Product Change Notification / ASER-25RLDG830

CCB 4279.002 Initial Notice: Qualification of GTK as a new assembly site for selected SST39VF3201xx and SST39VF3202xx device families available in 48L TSOP (12x20mm) package.

CCB 4279.002
Pre and Post Change Summary
PCN #: ASER-25RLDG830

LPI

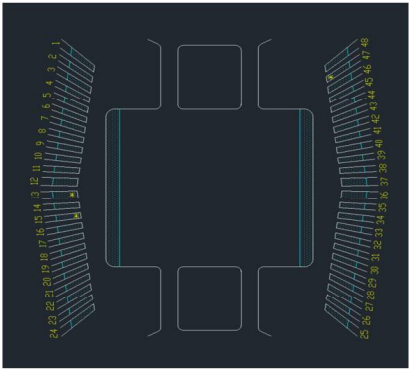
Paddle size	183 x 161 mils
-------------	----------------

GTK

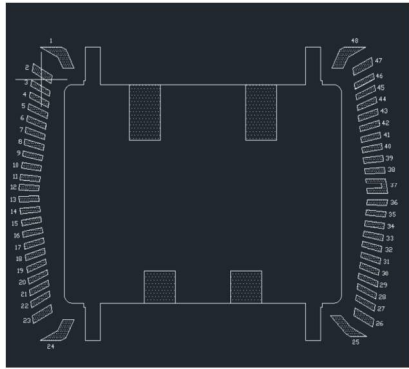
Paddle size	280 x 210 mils
-------------	----------------
